Addendum to "Application for Variance or Appeal," based on 2002 Building Code of NYS assembly exit requirements affecting crit room size (Exhibit 1) and mezzanine definition (Exhibit 4).

Jonathan Ochshorn
 May 31, 2013

Addendum 2 to “Application for Variance or Appeal,” pertaining to Exhibit 1 and Exhibit 4 (Rev.1)

Addendum 3 to "Application for Variance or Appeal": Review of documents in the City of Ithaca Building Department files

FLOOR B1 ENLARGED PLANS

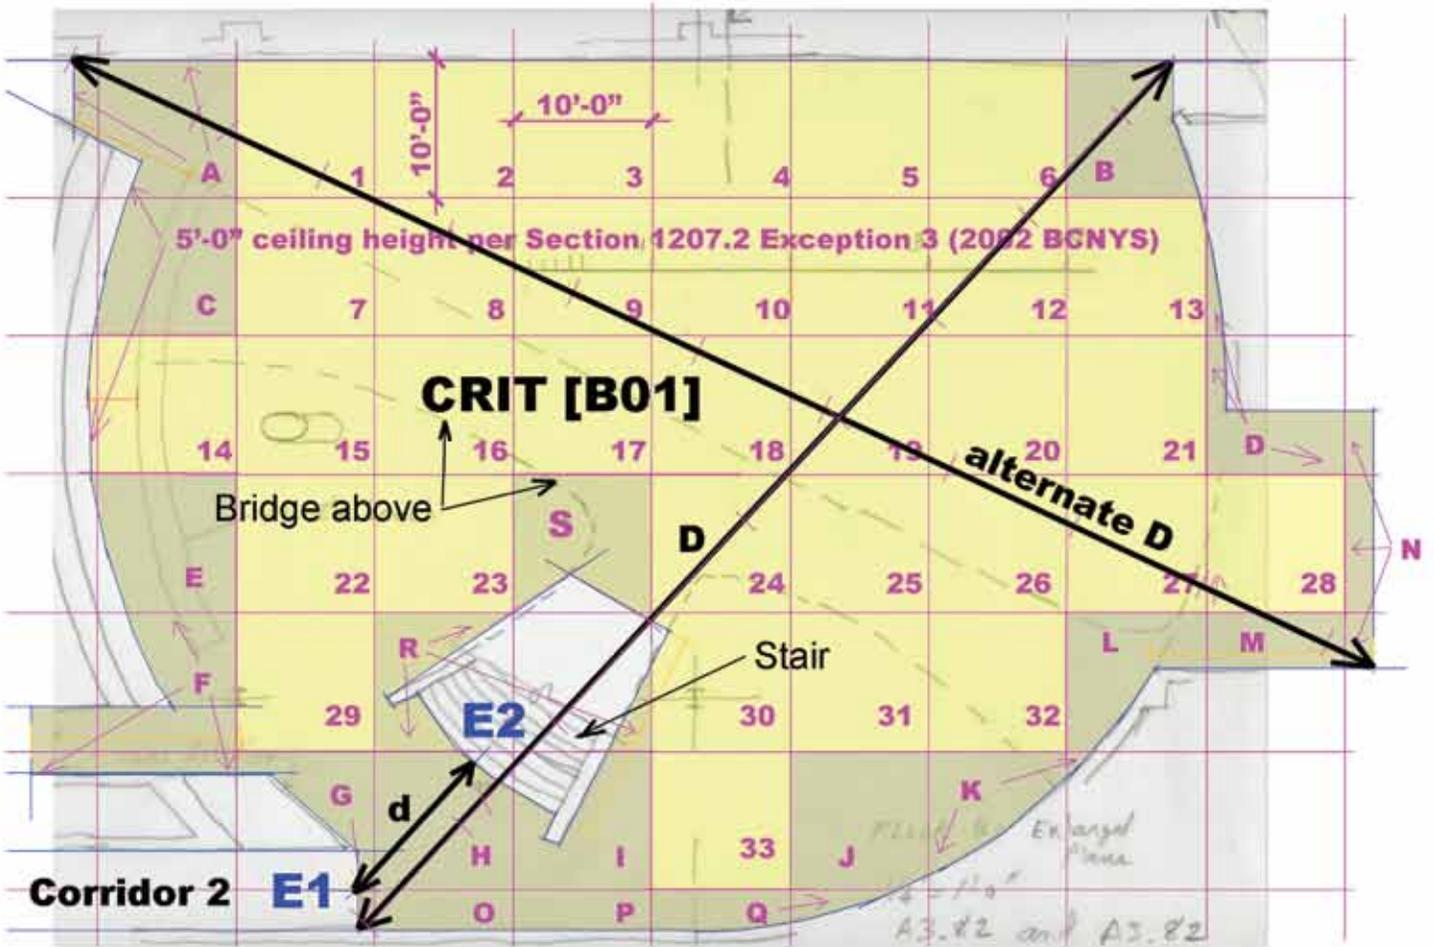
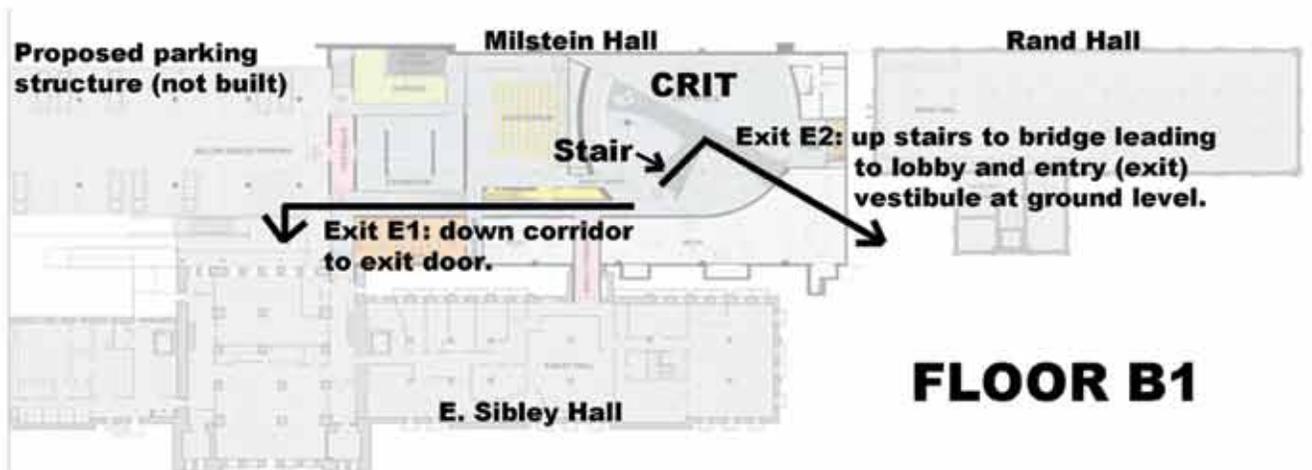
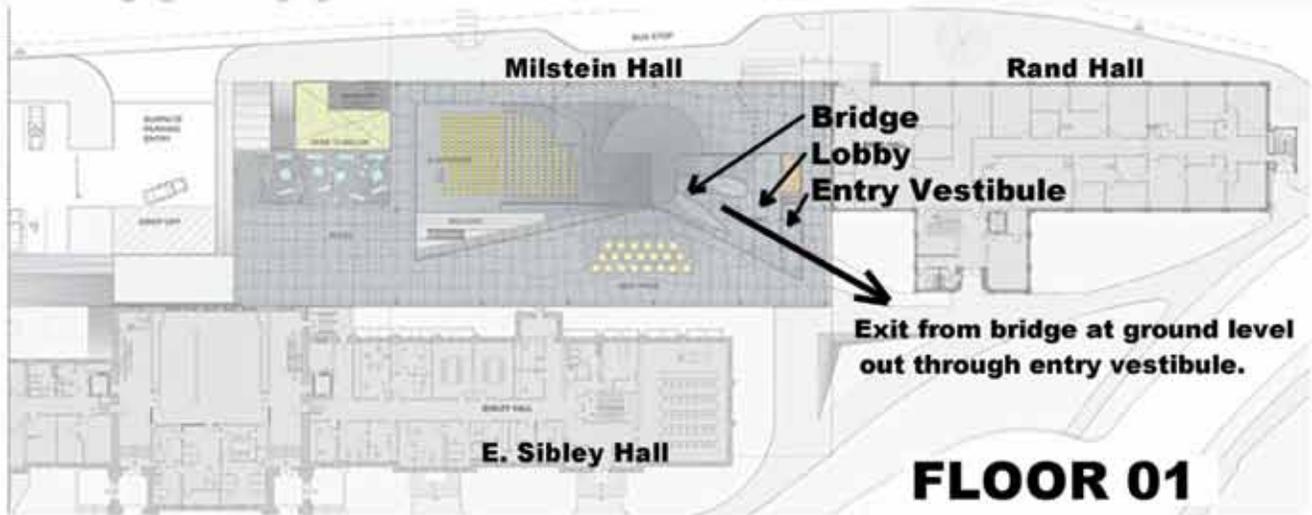
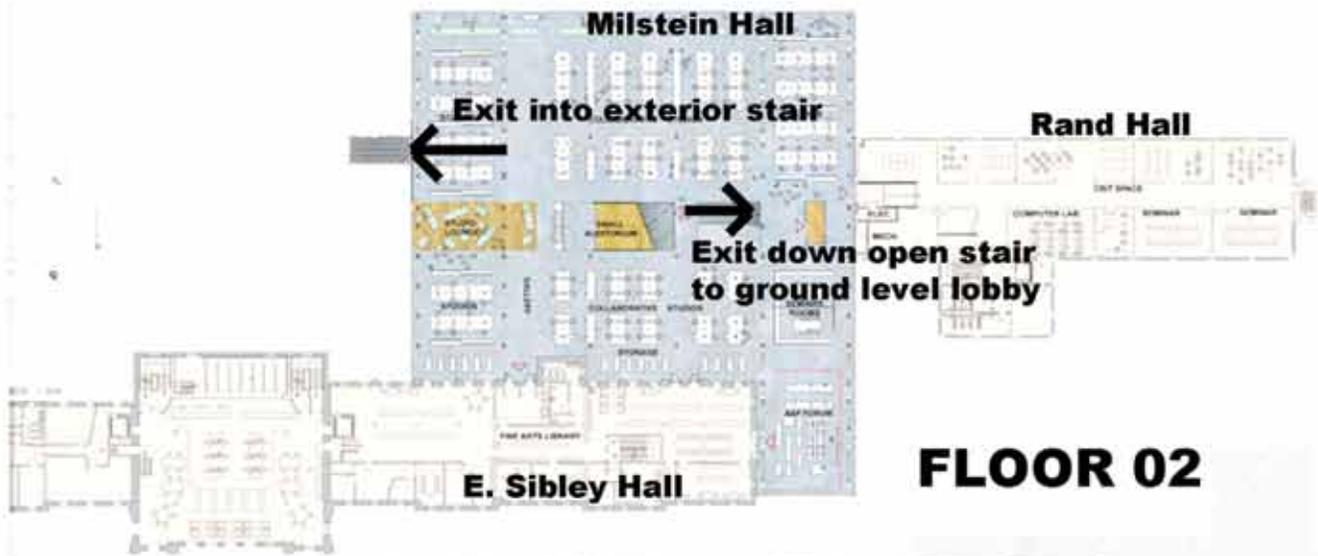
“On figure 2, you show dimensions D and d. I don’t see where these dimensions are defined in your exhibits. For areas like this, you should submit scalable drawings with dimensions so that the Board can easily look at the numbers or provide enough number so that the board can understand the problems. I am assuming that E1 and E2 are exits. Where do these exits go?”

“For the mezzanine issue, please provide sq. ft. numbers so the allowable area of the mezzanine can be calculated.”

I do not have scalable drawings, as they are the property of Cornell University and have not been made available to me, except for a half-size “Construction” set, dated Dec. 5, 2008, in the Fine Arts Library that I can examine but not photocopy. However, I have provided a carefully traced plan of the Crit room on page 2 of this addendum on which I have drawn a scaled 10-foot grid. These drawings show that the distance, *d*, between exits E1 and E2 (shown in Figure 2 of Exhibit 1) is **12’-0”** and that the “diagonal” distance, *D*, shown in the same figure, is **85’-0”**. I have confirmed the 12’-0” exit separation distance with a tape measure in the actual space.

The exit paths are shown superimposed on plans available on Cornell’s Milstein Hall website, reproduced on page 3 of this addendum. Exit E1 goes down a corridor labeled “Corridor 2” on the working drawings and exits through a door to a below-grade exterior passageway leading to a parking lot. Exit E2 goes up a stair within the Crit room to a “bridge” that leads to the ground level lobby and entry vestibule. These are the only exits from the Crit room space.

From the carefully scaled Crit room plan shown on page 2 of this addendum, the **Crit room floor area is 4580 square feet**. This is based on the total area, excluding the stair, up to a point where the domed ceiling height is 5 feet above the finish floor, per Section 1207.2 of the 2002 Building Code of NYS, Exception 3. This differs from the 4978 square foot figure provided by the Architects, but does not change any of the conclusions about the allowable Crit room size based on the number of exits (see the first Addendum).

d = 12'-0"
D = 85'-0"
alt. D = 105'-0"

TOTAL AREA = 3300 + 1280 = 4580 s.f.

Figure 1. Common path of egress travel shown superimposed over "moveable wall plans" provided by the building architects on Dec. 10, 2010 exceeds 75 feet (email from Kim Cleveland of Accufab to Ziad Shehab of OMA Architects; blue lines and dimensions added by J. Ochshorn)

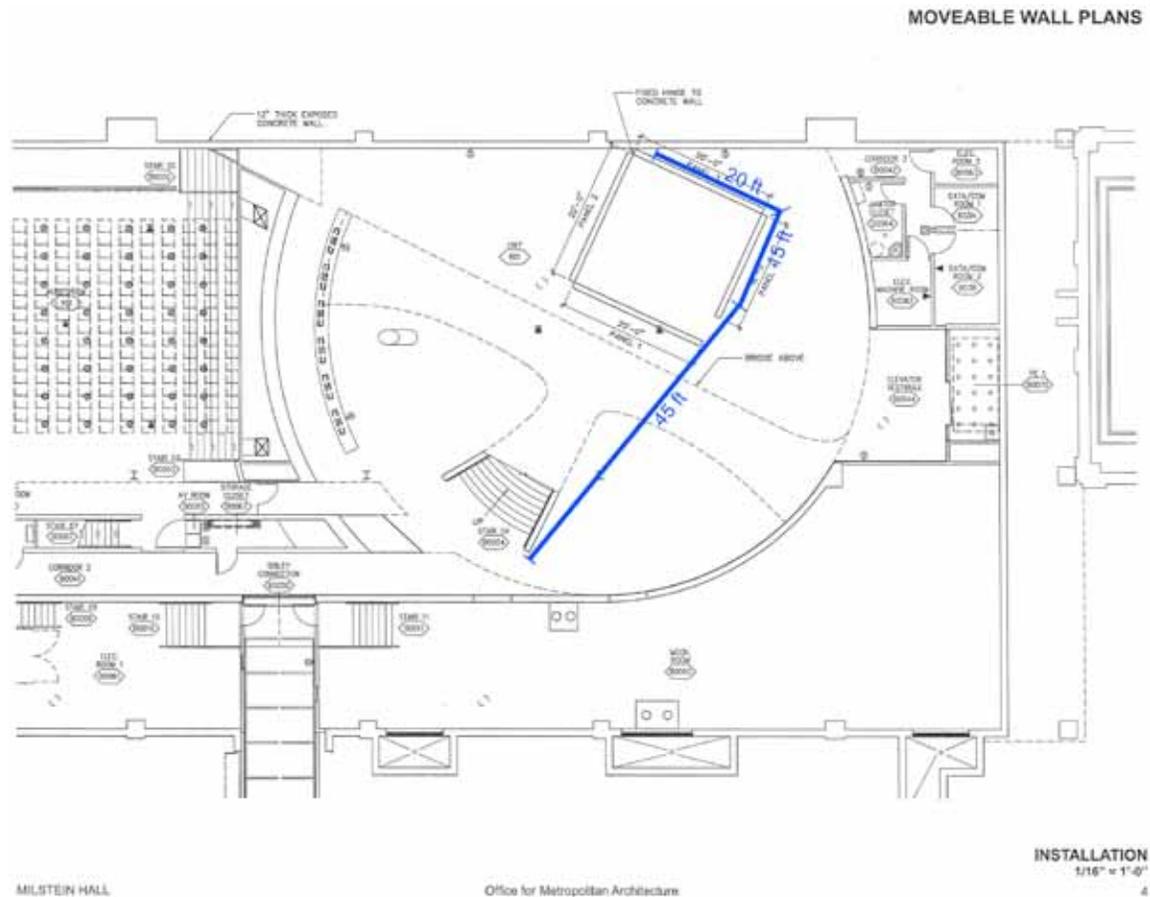
A plan of the crit room, found in the Building Department files for Milstein Hall, shows a 71-foot "Common Path" drawn as a straight line from the northeast "corner" of the room to the edge of the stair. As described in Exhibit 1, the common path of egress travel should be "assumed to be the natural path of travel without obstruction," and not an abstract "as-the-crow-flies" straight line. This is especially true now that permanent partitions have been installed in the room; such partitions can be configured so that the common path of egress travel cannot possibly be within the 75-foot limit (see Figure 1 based on "Moveable Wall Plans" prepared by OMA Architects).

But even without those partitions, the common path of egress travel requirement is not met in the crit room space, except by abstracting from all consideration of chairs, tables, or other impediments.

Figure 3. Fire separation shown separating the basement of Sibley from Milstein Hall (red lines have been added by J. Ochshorn to match what appeared in the original colored drawings, prepared by KHA Architects, dated 5/5/09).

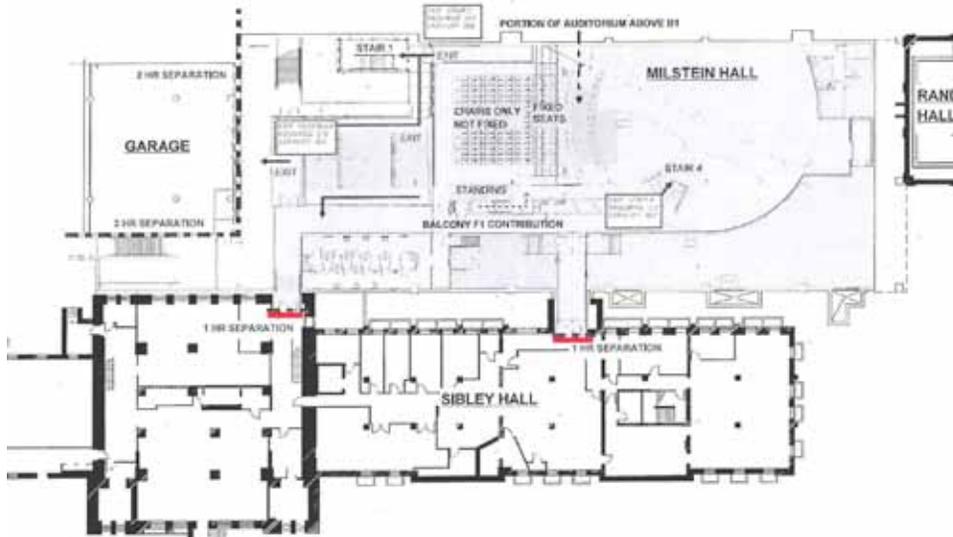
In these May 5, 2009 plans, one-hour fire separation is shown between the basement of Sibley and Milstein Halls (Figure 3), but only at the points of connection, and not for the windows in the basement of Sibley (although fire protection at those windows appears to have been provided).

Figure 4. Fire separation at the ground level of Milstein Hall (red lines have been added by J. Ochshorn to match what appeared in the original colored drawings, prepared by KHA Architects, dated 5/5/09).

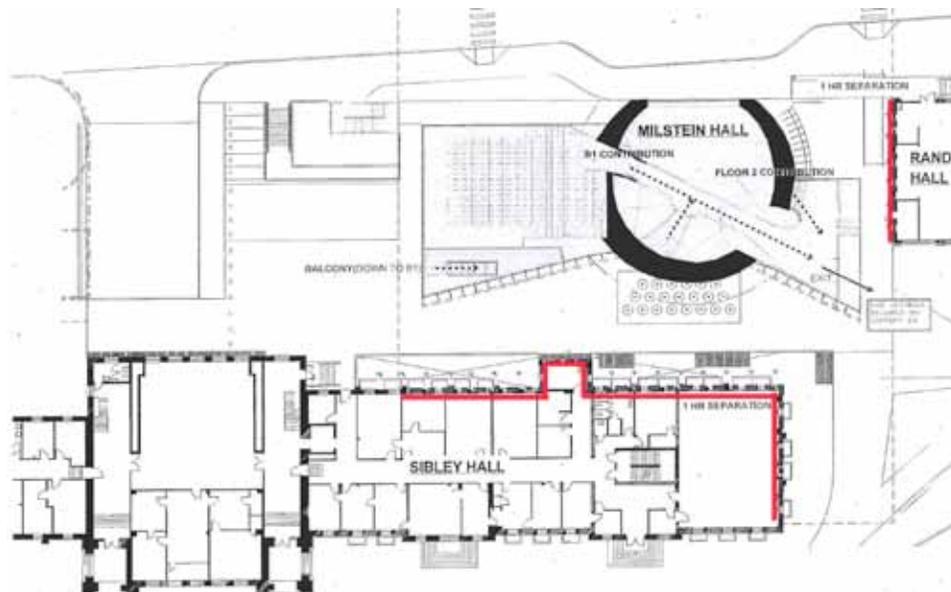
One-hour fire separation is shown between the first floors of Sibley and Milstein Hall and between Rand Hall and Milstein Hall (Figure 4). Fire protection at Rand Hall does not appear to have been provided, as a window and exhaust duct remain in that wall without any fire-resistance rating.

Figure 6 Plans show mezzanine as though it is within the combined crit room, auditorium, and the corridor connecting them.

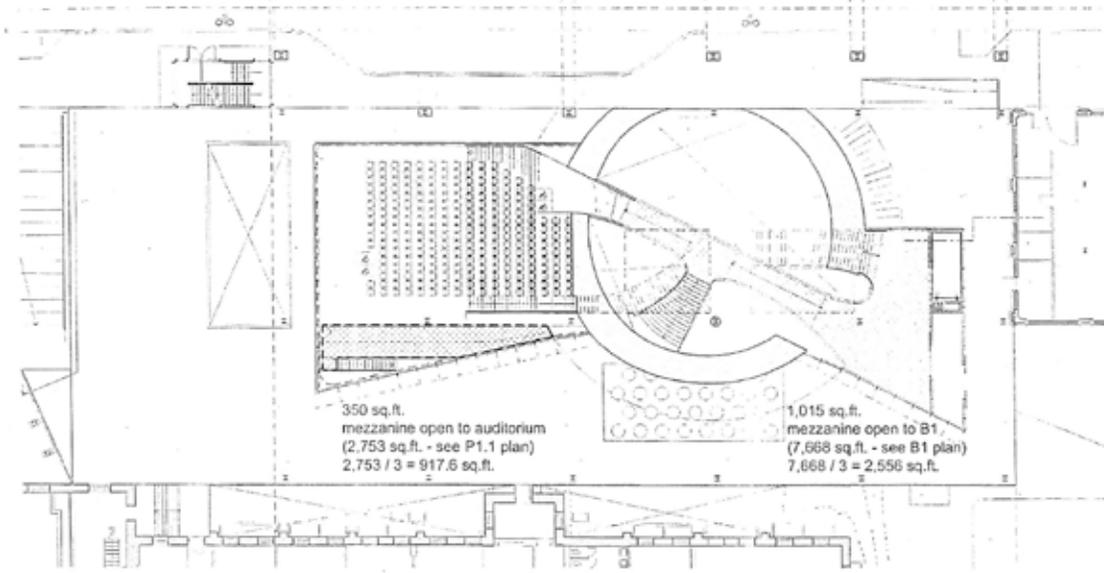
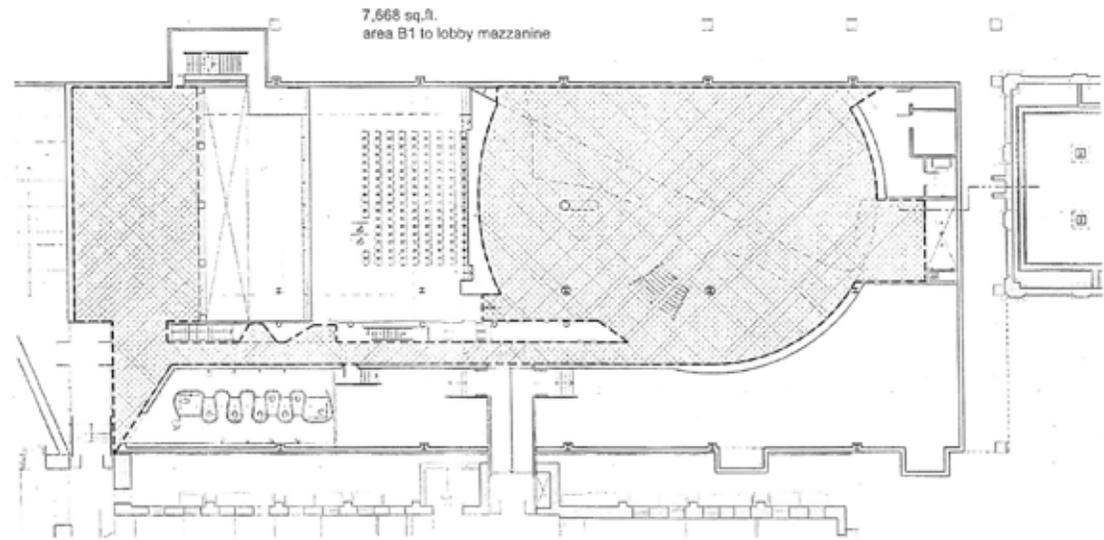
An email conversation between Larry Burns (KHA Architects) and Ziad Shehab (OMA Architects) shows that preliminary assumptions governing the designation of the lobby and bridge in Milstein Hall as a mezzanine were flawed. In order to increase the area of the room in which the mezzanine was located, that "room" was defined as a combination of the crit room, the lower part of the auditorium, *and* the corridor that connects the two spaces (see Figure 6 below). The building plans were altered subsequent to this email, so it is difficult to know exactly what the current assumptions are. The email thread reads as follows:

Ziad, we have a problem. With the increased Mezzanine area we now exceed the definition of mezzanine below and will be considered an atrium again..."
(emphasis added).
